Permit No: **980270**

RE: Chapman Passivator Area - Ventilation of Additional Rooms  
SMRT Project No. 97060-02

CHAPMAN PASSIVATOR ROOM  
(ADDENDUM)  
2/24/98 - BAILEY  
1/8" = 1'-0"

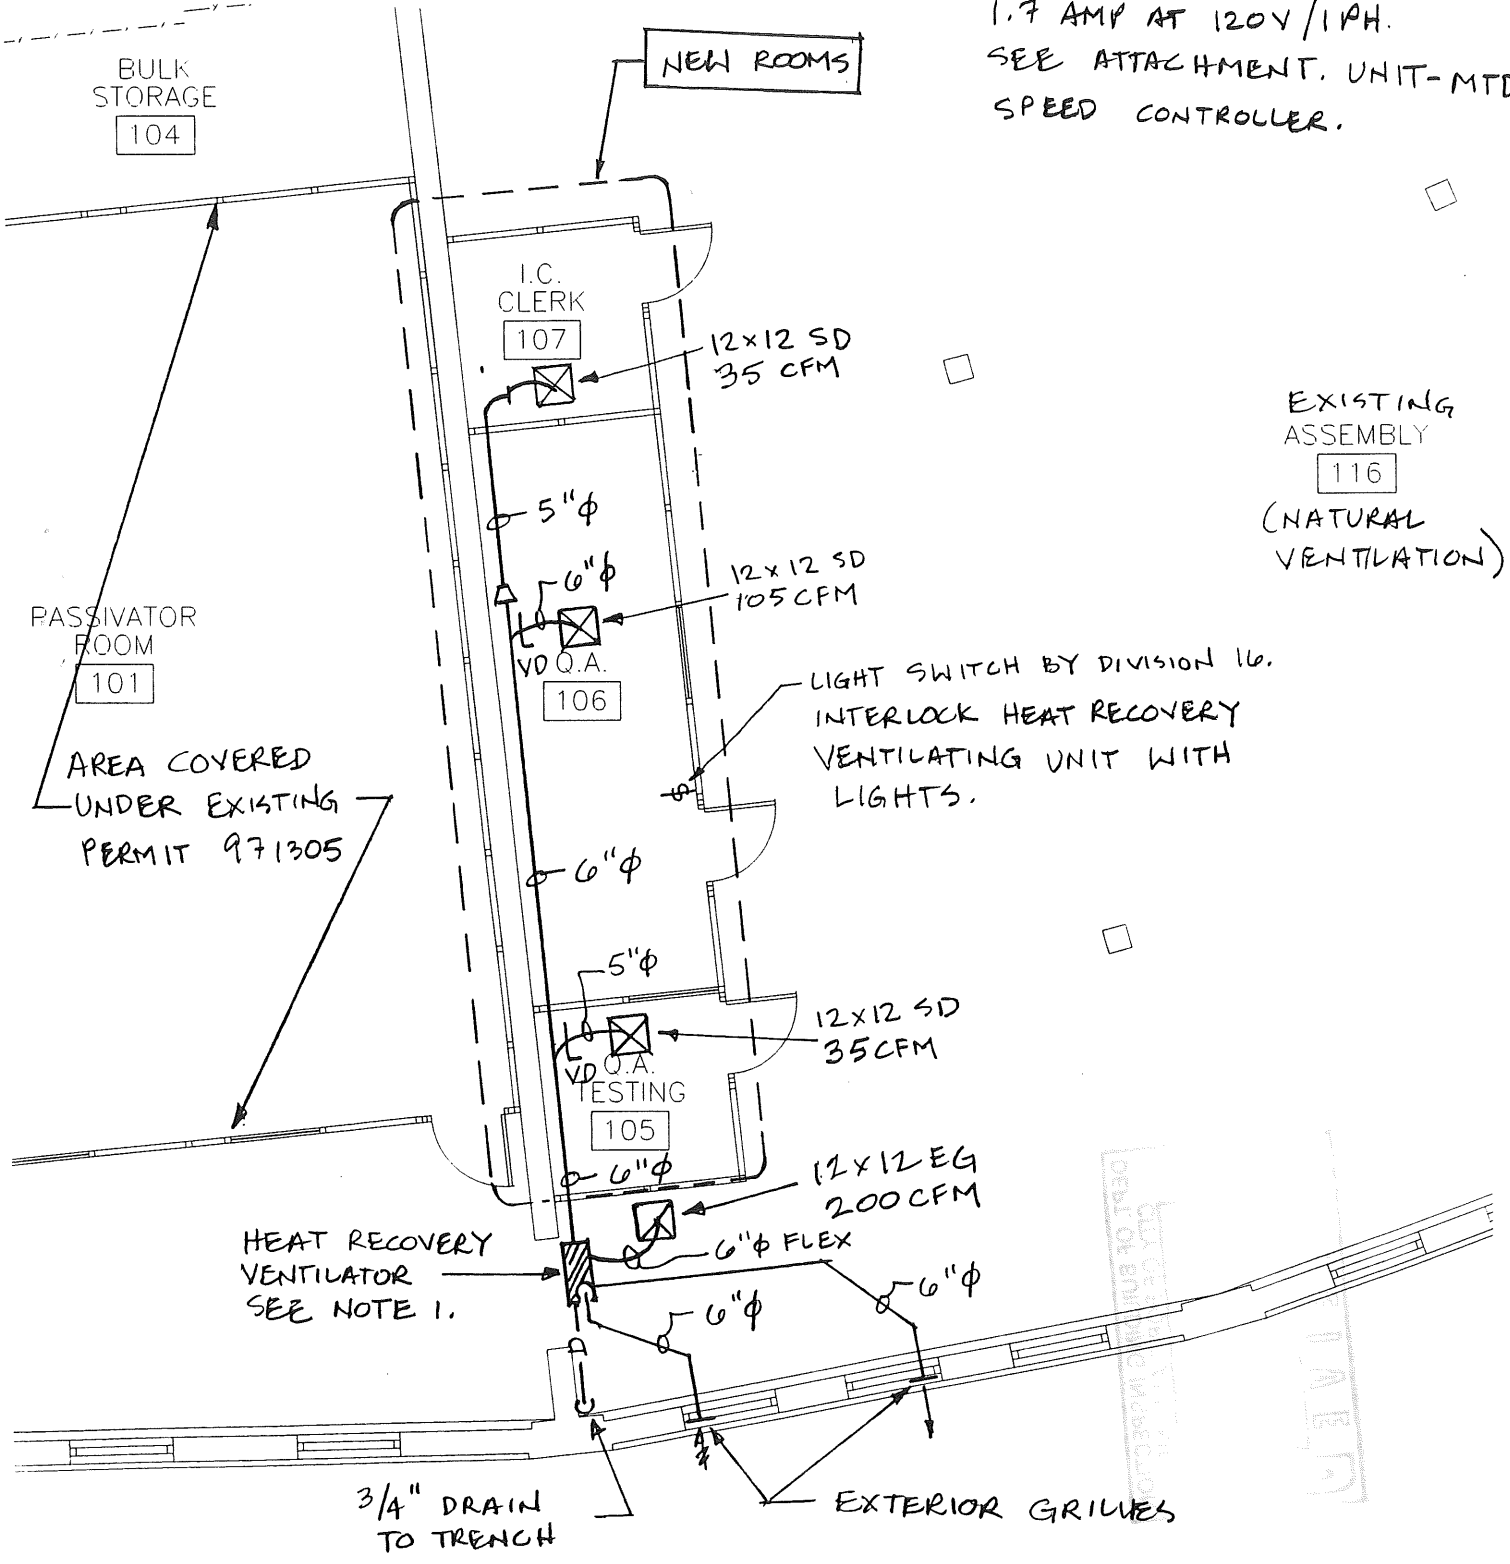
1. Bill Smith called 2/17/98 stating that the Building Inspector, during a pre-construction walk-thru, noticed that the three interior rooms 105, 106 and 107 were not provided with a means of ventilation. The Inspector, Mr. Mer Leary, stated that the building code requires that these rooms be ventilated. Bill stated that these rooms were added to the project after the building permit was issued. RTB and BS discussed the possible solutions, including continuous exhaust, removing the doors for natural ventilation, and exhaust to the ceiling

2. Mr. Leary was contacted 2/18/97 and stated that a permit should be obtained for the additional three rooms. Mr. Leary stated that it can be obtained as an addendum to the original permit. In a 2/24 conversation with Sam Hoffses/Plan Review, the rooms must meet the 1993 BOCA Mechanical Code requirements for natural or mechanical ventilation.

- a. One unacceptable solution is natural ventilation through Assembly by removing the office doors. The Mechanical Code allows natural ventilation of an interior space through a perimeter space that is naturally ventilated. The perimeter space must have operable windows/doors that total an area at least 4% of the floor area. The Assembly Room (3800 sf), with only three operable windows (area 3' x 4' each) and one door opening (48 sf) does not meet that criteria (2.2%). In other words, the Assembly Room does not have adequate ventilation to begin with. Therefore, in SMRT's professional opinion, the Assembly Room should not be used for natural ventilation of the three rooms.

- b. Another unacceptable solution is to continuously exhaust the spaces (6 ACH) and makeup from the Assembly Room. At first glance, this solution appears to provide adequate ventilation for the spaces. The Mechanical Code, however, does not allow transfer air to satisfy the outdoor air requirements and, therefore, SMRT cannot endorse this solution.

- c. The solution that provides adequate ventilation at the least first cost is a "heat recovery ventilator that uses exhaust air to preheat outdoor air. The outdoor air is then ducted to the individual spaces. The ventilator should be Honeywell ER200 or an approved equal.

- HEAT RECOVERY VENTILATOR ABOVE CEILING, HONEYWELL HR200C, 184 CFM OUTSIDE AIR AT 0.4" SP. 1.7 AMP AT 120V/1PH. SEE ATTACHMENT. UNIT-MTD. SPEED CONTROLLER.

CHAPMAN PASSIVATOR ROOM  
(ADDENDUM)  
2/24/98 - BAILEY  
1/8" = 1'-0"

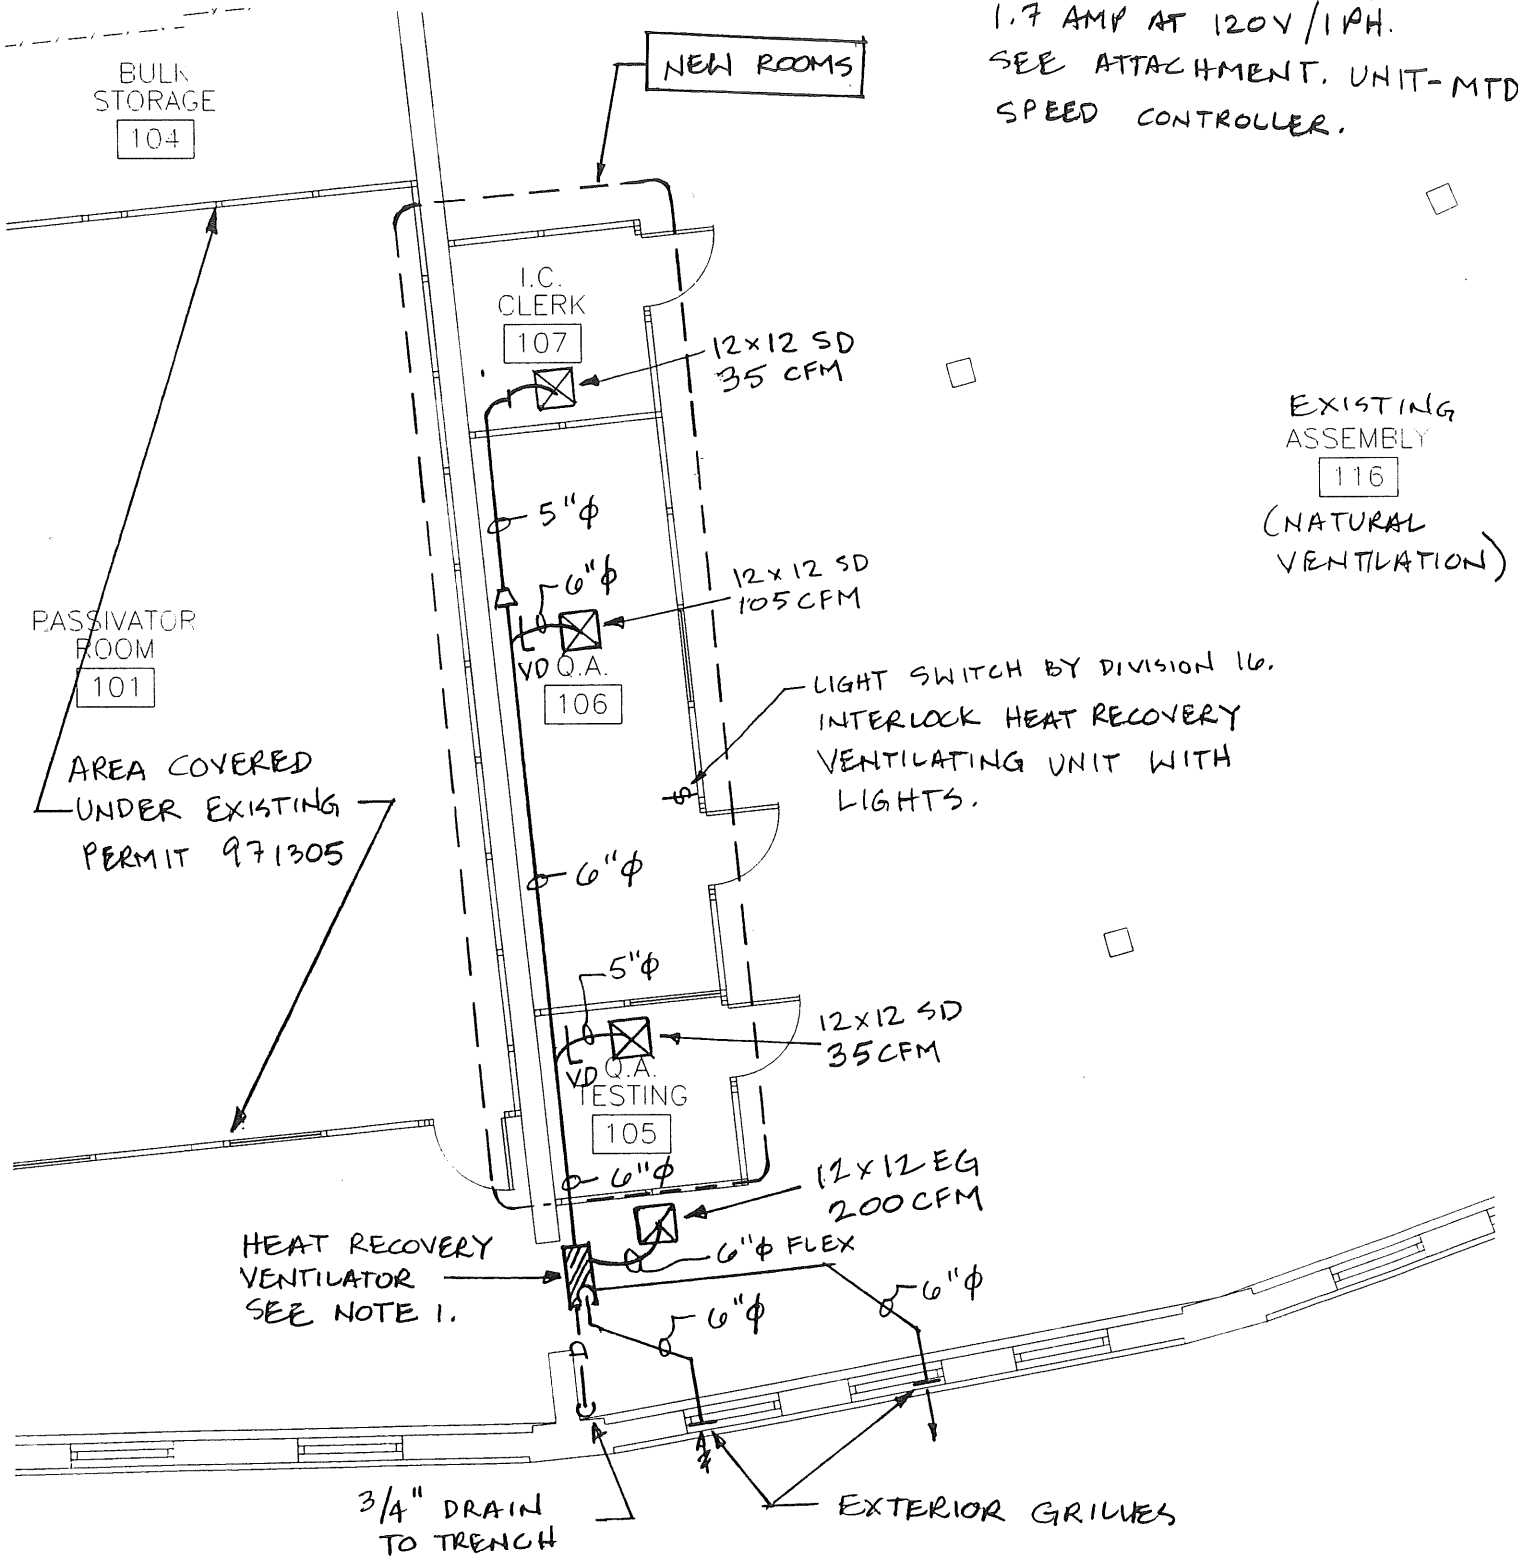
1. Bill Smith called 2/17/98 stating that the Building Inspector, during a pre-construction walk-thru, noticed that the three interior rooms 105, 106 and 107 were not provided with a means of ventilation. The Inspector, Mr. Mer Leary, stated that the building code requires that these rooms be ventilated. Bill stated that these rooms were added to the project after the building permit was issued. RTB and BS discussed the possible solutions, including continuous exhaust, removing the doors for natural ventilation, and exhaust to the ceiling

2. Mr. Leary was contacted 2/18/97 and stated that a permit should be obtained for the additional three rooms. Mr. Leary stated that it can be obtained as an addendum to the original permit. In a 2/24 conversation with Sam Hoffses/Plan Review, the rooms must meet the 1993 BOCA Mechanical Code requirements for natural or mechanical ventilation.

- a. One unacceptable solution is natural ventilation through Assembly by removing the office doors. The Mechanical Code allows natural ventilation of an interior space through a perimeter space that is naturally ventilated. The perimeter space must have operable windows/doors that total an area at least 4% of the floor area. The Assembly Room (3800 sf), with only three operable windows (area 3' x 4' each) and one door opening (48 sf) does not meet that criteria (2.2%). In other words, the Assembly Room does not have adequate ventilation to begin with. Therefore, in SMRT's professional opinion, the Assembly Room should not be used for natural ventilation of the three rooms.

- b. Another unacceptable solution is to continuously exhaust the spaces (6 ACH) and makeup from the Assembly Room. At first glance, this solution appears to provide adequate ventilation for the spaces. The Mechanical Code, however, does not allow transfer air to satisfy the outdoor air requirements and, therefore, SMRT cannot endorse this solution.

- c. The solution that provides adequate ventilation at the least first cost is a "heat recovery ventilator that uses exhaust air to preheat outdoor air. The outdoor air is then ducted to the individual spaces. The ventilator should be Honeywell ER200 or an approved equal.

- HEAT RECOVERY VENTILATOR ABOVE CEILING, HONEYWELL HR200C, 184 CFM OUTSIDE AIR AT 0.4" SP. 1.7 AMP AT 120V/1PH. SEE ATTACHMENT. UNIT-MTD. SPEED CONTROLLER.

STAIR & LANDING PLAN

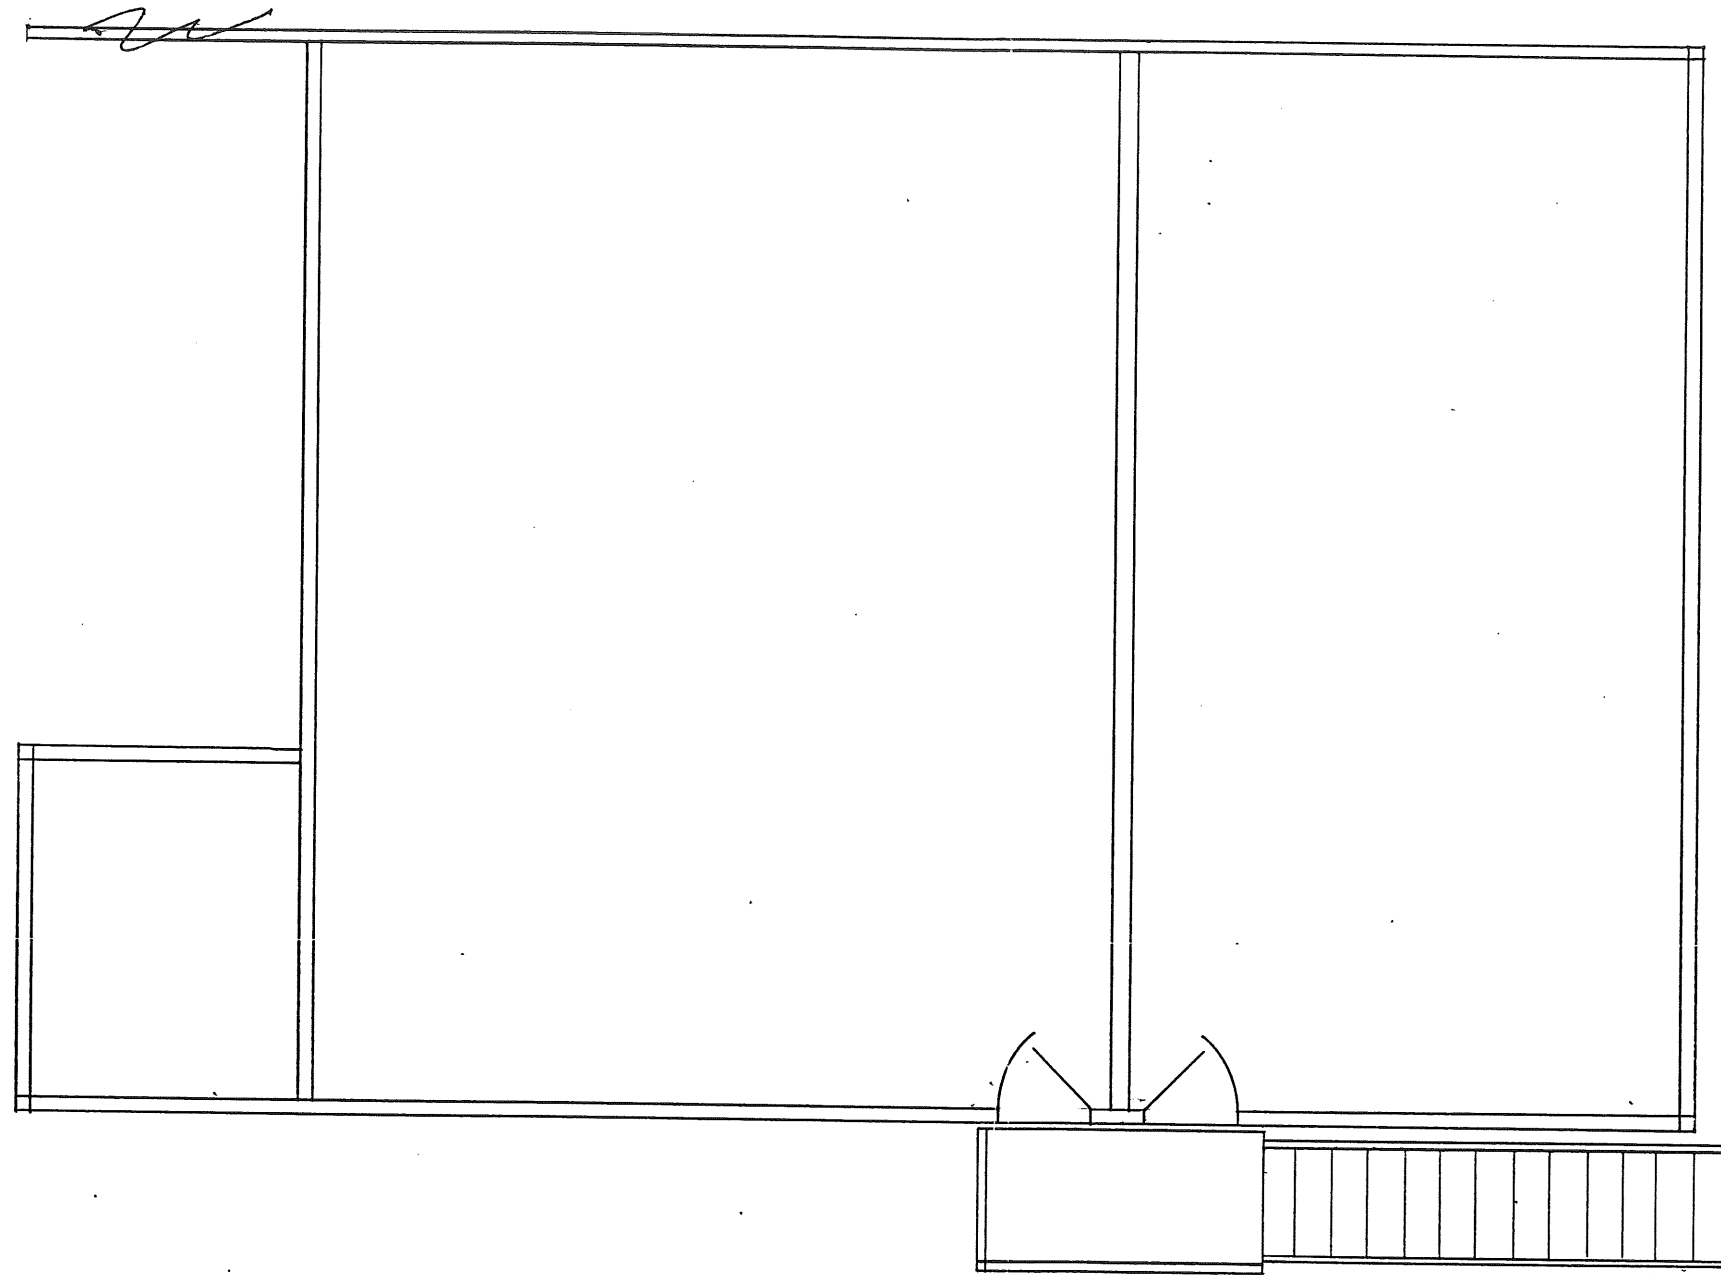
In response to your inquisition about the order shipping to Coastal Equipment Corporation or any of our standard stairways, there was a concern about the strength of the 3/8 inch bolts supplied to fasten the staircases was not sufficient.

Calculating a worse condition scenario of the application, which is a single-shear lap-joint made with the connection of the 3/16 inch thick angle to bar capping the end of the 10" structural channel with 8 pieces of a 3/8 inch grade 5 bolts, the total allowable load is 6376 lbs.

Considering this worse case scenario, the staircase is a dead load of 1245 lbs which allows 5130# of live load. Over and above the criteria used, the structural channel at the bottom of the staircase is resting directly on the floor therefore the bolts are merely used as a position restraint for the anchoring brackets. At the top of the staircase the shear forces are reduced by approximately 40% (if the bottom of the staircase is properly anchored) due to the pivot and triangulation effect created by the anchors at the bottom of the staircase. The actual vertical load applied at this position becomes 60% vertical and 40% horizontal.

In conclusion, using standard structural design criteria, the hardware supplied is more than sufficient for the application.
